**Report of the
MQXFA13b
Structure & Shim Review**

US HL-LHC Accelerator Upgrade Project

January 10th 2024

Summary Coil radial (shimmed) deviation and key/shim size

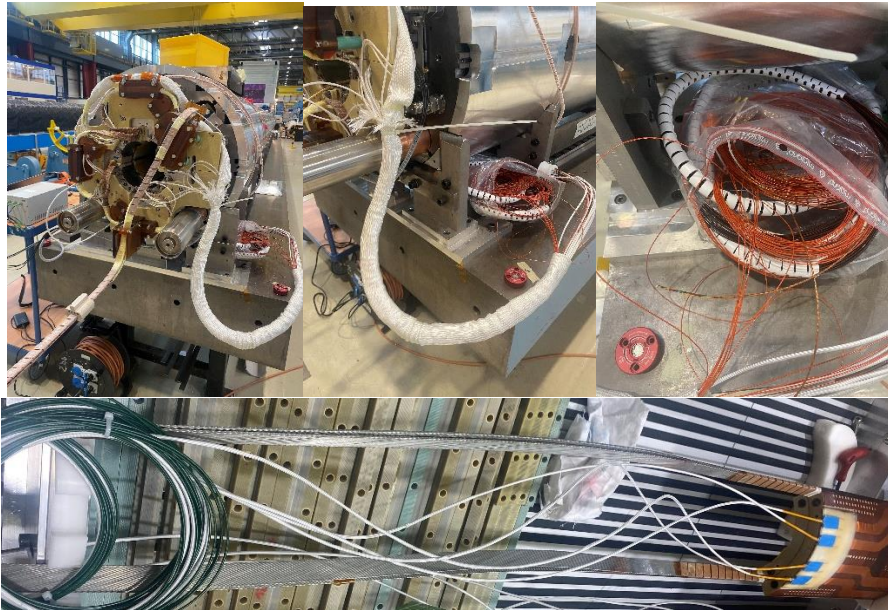
- Since the review, an attempt was made to assess the effects of the outer radius deviations that are introduced by fitting with the OR + midplane profile, by Paolo Ferracin. His conclusions are shown in HiLumi doc 4969. Small coils have a systematic negative deviation on the outer radius, and looking at the lead end (where MQXFA07/08/13 were limited), the magnet-to-magnet difference is up to 0.05 mm. This is not a negligible effect for the target key size which is now in a range of 0.075 mm (3 to 4 mils). Specific data from MQXFA13b is not included here and should be used instead of averages when assessing the preload.
